## V2500-A5 SERIES PROPULSION SYSTEM NON-MODIFICATION SERVICE BULLETIN

**V2500-ENG-73-0232**  
Transmittal - Page 1 of 1

NON-MODIFICATION SERVICE BULLETIN – ENGINE PRESSURE RATIO (EPR) MODIFIER CLASS  
CORRECTION DUE TO TEST CELL CALIBRATION SHIFT

DATA ENTRY PLUG (DEP) ASSEMBLY  
FIGURE 2

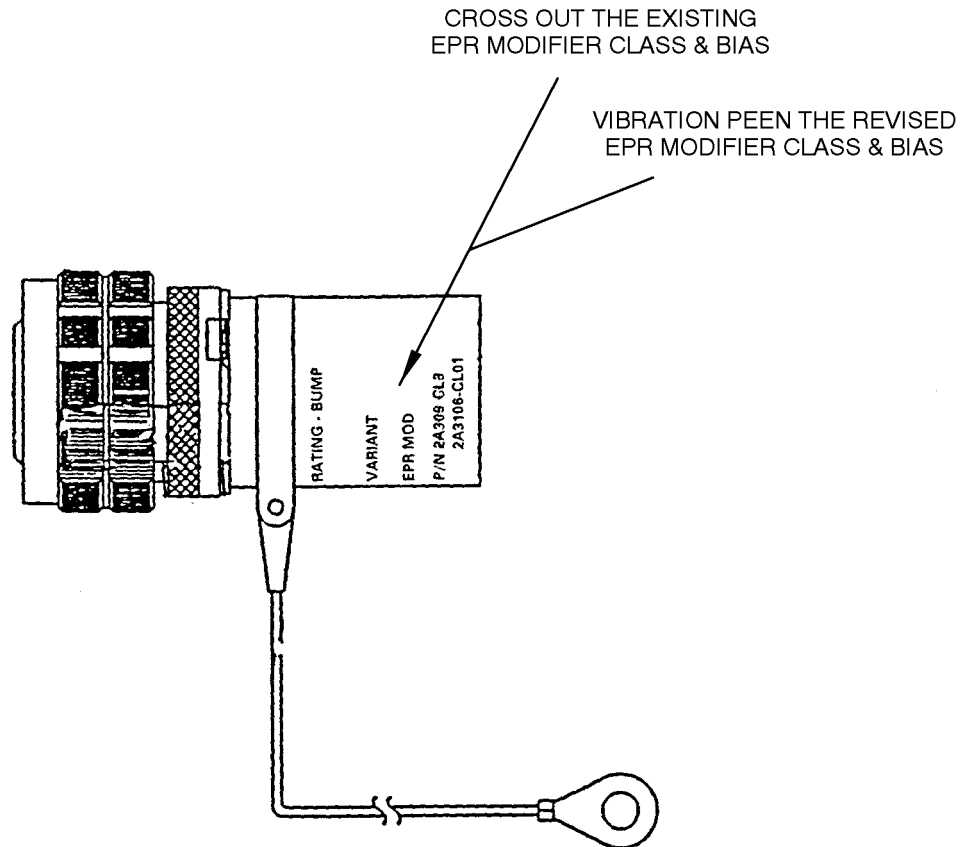
- (d) Locate the existing EPR Modifier Class and Bias in Table 2 for the corresponding Engine Serial Number. Make note of the pin connections for Channel A and B listed in Table 3. Highlight only these pin connections in "Pre SB 73-0232 Jumper Pin Connectors".
- (e) Locate the revised EPR Modifier Class and Bias using Table 2. Make note of the pin connections for Channel A and B listed in Table 3 on the diagram in "Post SB 73-0232 Jumper Pin Connectors".
- (f) Ignore the highlighted EPR Modifier Class and Bias connections in "Pre SB 73-0232 Jumper Pin Connectors" and copy the rest of the connections to the diagram in "Post SB 73-0232 Jumper Pin Connectors".
- (g) Determine the jumper pin changes required from the differences between the diagrams in "Pre SB 73-0232 Jumper Pin Connectors" and "Post SB 73-0232 Jumper Pin Connectors" and new jumpers needed. See Figure 2.

- (h) Modify the DEP Connector to change the wiring per diagram in "Post SB 73-0232 Jumper Pin Connectors". Refer to repair VRS3500 in Reference 3, AMM Task 73-22-35.

IDENTIFICATION OF THE EPR MODIFIER CLASS AND THE DATA ENTRY PLUG ASSEMBLY  
FIGURE 3

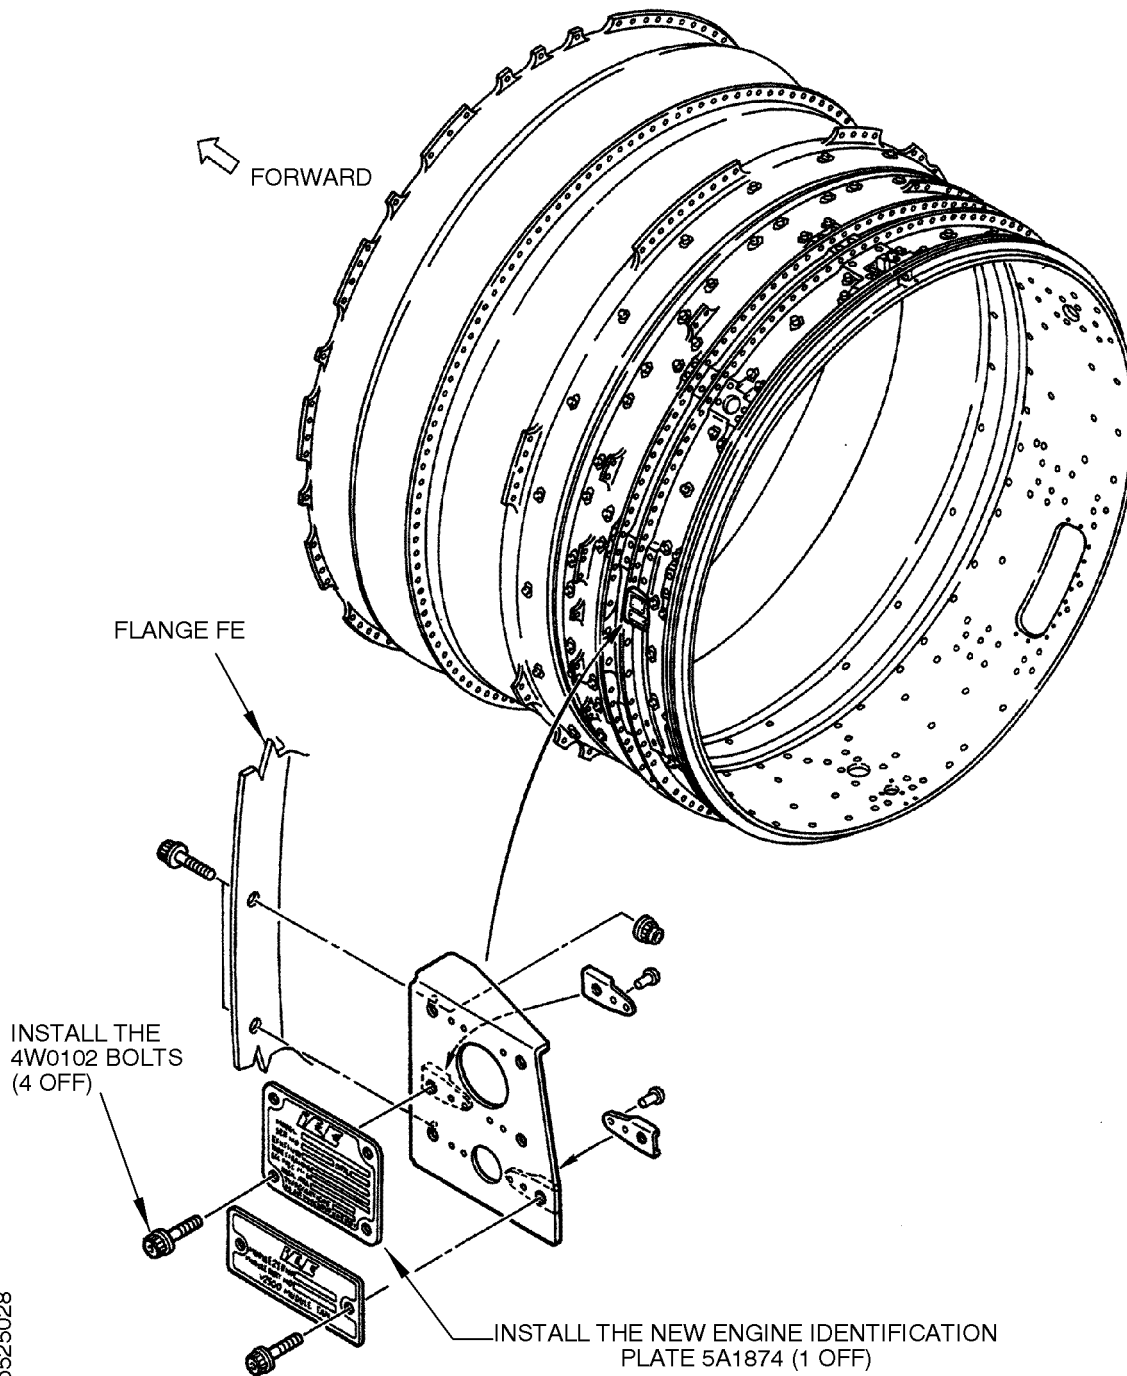
- (7) If required, install a new Engine Identification Plate. See Figure 3.
- (a) If Engine Identification Plate, PN 5A1874 is replaced by the same Part Number plate:

CONTACT HOLE LOCATIONS  
FIGURE 5

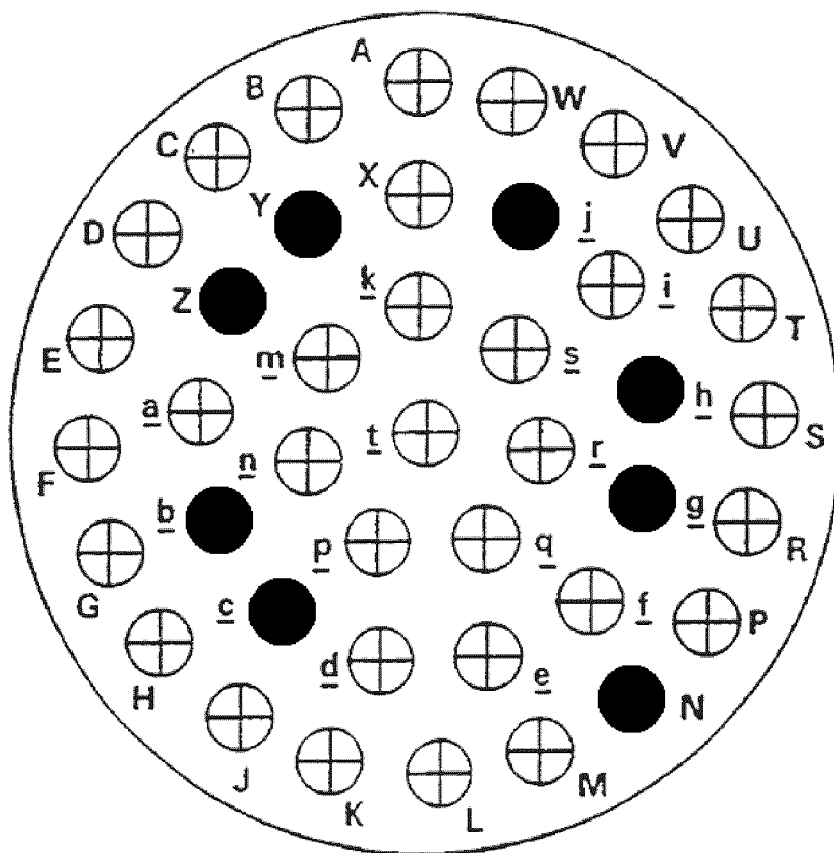
- (b) Make two copies of Figure 5 (Contact Hole Locations) of this Non-Modification Service Bulletin. Identify one diagram as "Pre SB 73-0232 Jumper Pin Connectors" and the other as "Post SB 73-0232 Jumper Pin Connectors".
- (c) Mark the existing DEP connections on the diagram in "Pre SB 73-0232 Jumper Pin Connectors". Make sure that the existing DEP wiring connections for EPR Modifier Class and Bias confirms to the wiring connections provided in Table 3 under "Existing EPR Modifier Class and Bias" for the corresponding Engine Serial Number listed in Table 2. After marking, make sure that all the connections originate from the ground pin to the non-ground pin. If not, re-arrange the marking to meet this requirement. See Figure 6 for ground pins in the DEP.

NOTE: Make two (2) copies of this diagram and identify one diagram as "Pre SB 73-0232 Jumper Pin Connections" and the other as "Post SB 73-0232 Jumper Pin Connections"
